## Issue List

### NCANG Repair Bldg 51 (Charlotte, NC)

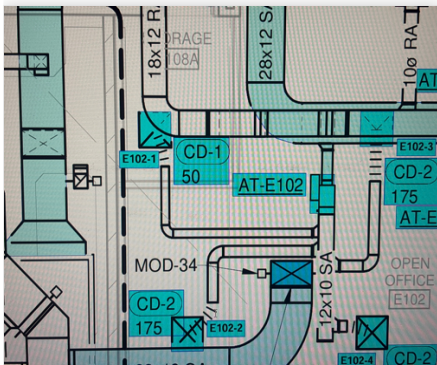
**Issue Name :** VAV AT-E102 Missing Diffuser  
**Description :** Diffuser E102-1 is missing in room STORAGE 108A  
**Created By :** National TAB                      **Assigned To :** National TAB - Antonio Flores-De La Cruz  
**Status :** Open  
**Priority :**    **Asset Tag :**  
**Originated Date :** 01/21/2026 - Antonio Flores-De La Cruz - National TAB

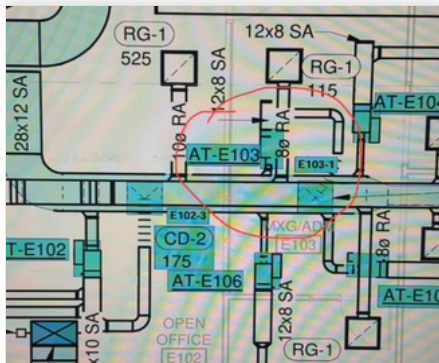
**Issue Name :** VAV AT-E103 Wrong Location  
**Description :** VAV AT-E103 is installed in the wrong location per the drawings. It should have been installed in MXG/ADM E103, but instead was installed in room OPEN OFFICE E102.  
**Created By :** National TAB                      **Assigned To :** National TAB - Antonio Flores-De La Cruz  
**Status :** Open  
**Priority :**    **Asset Tag :**  
**Originated Date :** 01/21/2026 - Antonio Flores-De La Cruz - National TAB

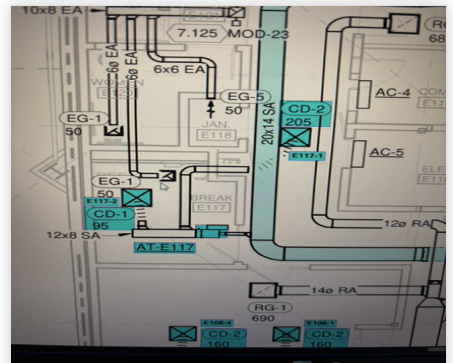
**Issue Name :** VAV AT-E117 Missing Grille  
**Description :** Diffuser E117-1 in CORRIDOR E115 is missing. Upon inspection, it appears that the duct is attached to the VAV but it stops at the brick wall of room BREAK E117 and doesn't penetrate to the other side.  
**Created By :** National TAB                      **Assigned To :** National TAB - Antonio Flores-De La Cruz  
**Status :** Open  
**Priority :**    **Asset Tag :**  
**Originated Date :** 01/21/2026 - Antonio Flores-De La Cruz - National TAB

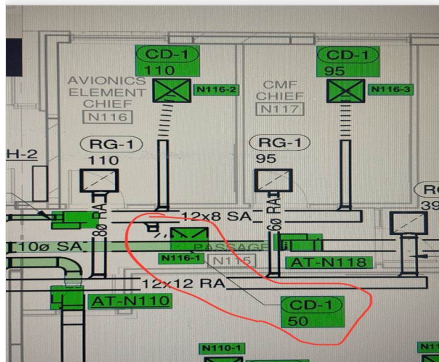
**Issue Name :** VAV AT-N116 Missing Diffuser  
**Description :** Diffuser missing in Passage N115 (N116-1).  
**Created By :** National TAB                      **Assigned To :** National TAB - Antonio Flores-De La Cruz  
**Status :** Open  
**Priority :** **Urgent**                                      **Asset Tag :**  
**Originated Date :** 11/11/2025 - Antonio Flores-De La Cruz - National TAB

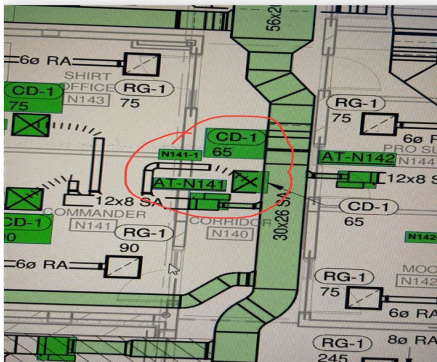
**Issue Name :** VAV AT-N141 Missing Diffuser  
**Description :** Diffuser in Corridor N140 (N141-1) is missing.  
**Created By :** National TAB                      **Assigned To :** National TAB - Antonio Flores-De La Cruz  
**Status :** Open  
**Priority :** **Urgent**                                      **Asset Tag :**  
**Originated Date :** 11/11/2025 - Antonio Flores-De La Cruz - National TAB

- **01/21/2026 National TAB - Antonio Flores-De La Cruz**
  - SAW MECHANICAL CONTRACTOR FIXING ISSUE, WILL CHECK

- **11/12/2025 National TAB - Antonio Flores-De La Cruz**
  - Diffuser was installed, but after attempting to balance, the supply grille in Shirt Office N143 (N141-2) is swapped with the grille for the return. It must be swapped.
